NL-03-2067

**VOGTLE ELECTRIC GENERATING PLANT
REQUEST TO REVISE TECHNICAL SPECIFICATIONS
REVISION TO SURVEILLANCE REQUIREMENTS 3.3.1.2 AND 3.3.1.3**

MARKED-UP TECHNICAL SPECIFICATION AND BASES PAGES

SR 3.3.1.2

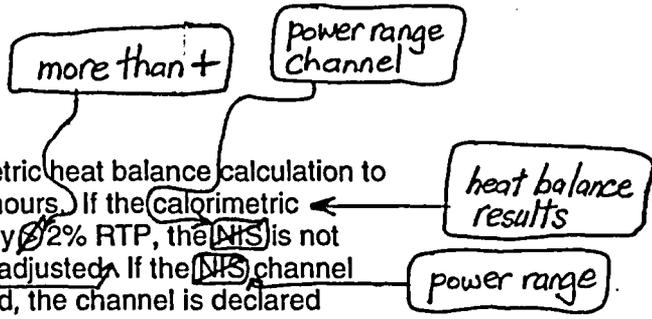
Two Notes modify SR 3.3.1.2. The first Note indicates that the NIS channel output shall be adjusted consistent with the calorimetric results if the absolute difference between the NIS channel output and the calorimetric power is $> 2\%$ RTP. The second Note clarifies that this Surveillance is required only if reactor power is $\geq 15\%$ RTP and that 12 hours is allowed for performing the first Surveillance after reaching 15% RTP. At lower power levels, calorimetric data are inaccurate.

that a difference between

calorimetric

calculation and the power range channel output of more than $+2\%$ RTP is not expected

Add Insert

If the calorimetric is performed at part power (<50% RTP), adjusting the power range channel indication in the increasing direction will assure a reactor trip below the safety analysis limit of 118% RTP. Making no adjustment to the power range channel in the decreasing power direction due to a part-power calorimetric assures a reactor trip consistent with the safety analyses.
